KETCHUM FIRE STATION DESIGN REVIEW
STAFF REPORT
KETCHUM PLANNING AND ZONING COMMISSION
REGULAR MEETING OF FEBRUARY 10, 2020

PROJECT: Ketchum Fire Station

FILE NUMBER: P20-013

APPLICATION: Design Review

LANDSCAPE PLAN

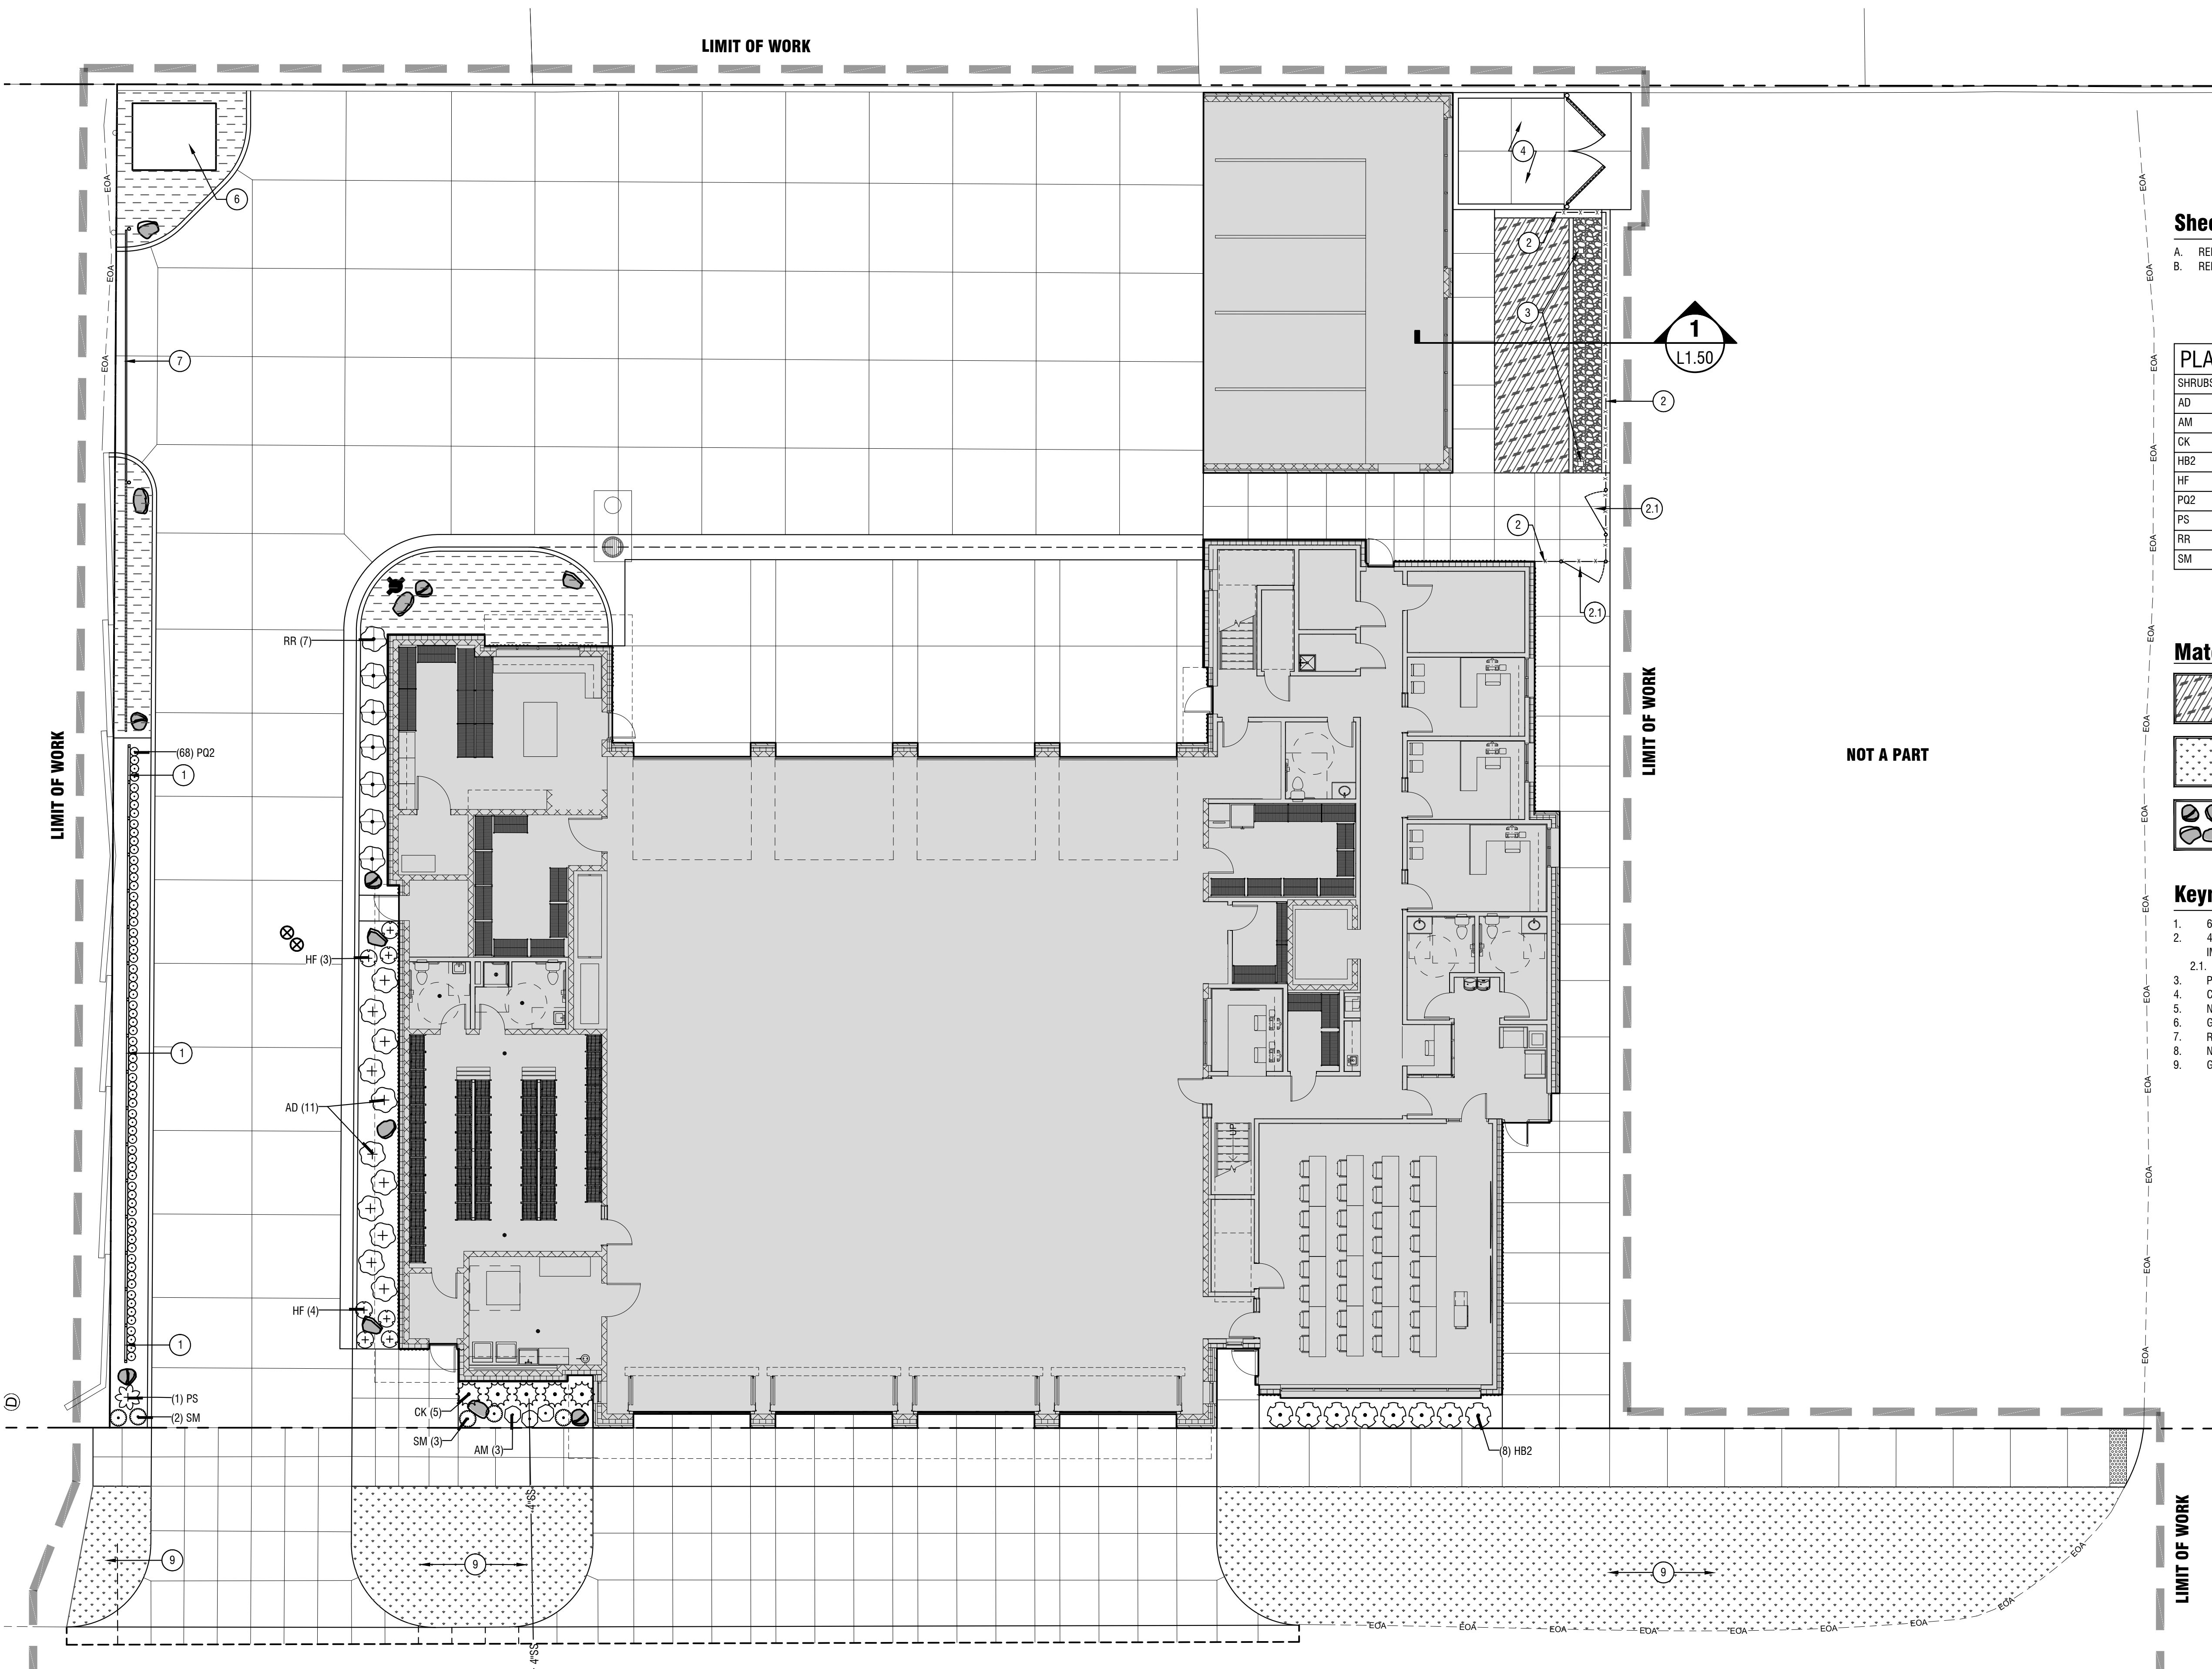
<input checked="" type="checkbox"/>	<input type="checkbox"/>	<input type="checkbox"/>	17.96.060.11 Landscaping	Landscaping is required for all projects.
			<i>Staff Comments</i>	<i>The landscape plan is included on Sheets L1.00 and L1.50 of the project plans. The grasses, flowering plants, and shrubs complement the fire station's modern design.</i>
<input checked="" type="checkbox"/>	<input type="checkbox"/>	<input type="checkbox"/>	17.96.060.12 Landscaping	Landscape materials and vegetation types specified shall be readily adaptable to a site's microclimate, soil conditions, orientation and aspect, and shall serve to enhance and complement the neighborhood and townscape.
			<i>Staff Comments</i>	<i>The landscape materials and vegetation types shall be readily adaptable to the site's microclimate, soil conditions, orientation, and aspect. The proposed landscaping will soften the fire station's hard lines and rectangular mass. Bordering the front property line, the tall grasses and flowering plants augment the welcoming entryway to the fire station.</i>
